Technical Information Bulletin

ECM Mount Modification{7000}

Media Number -TIBU7306-00

CT660 (S/N: TRK1-UP; TKL1-UP; TJS1-UP; TGT1-UP; TSW1-UP; TSY1-UP)

Illustration 1

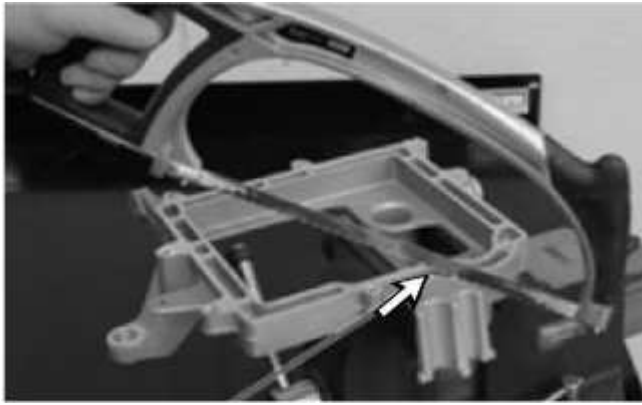
The engine harness can rub on the harness mounting location of the ECM mount.

1. Using a hack-saw or other acceptable method, cut off harness support bracket from bottom of ECM bracket.
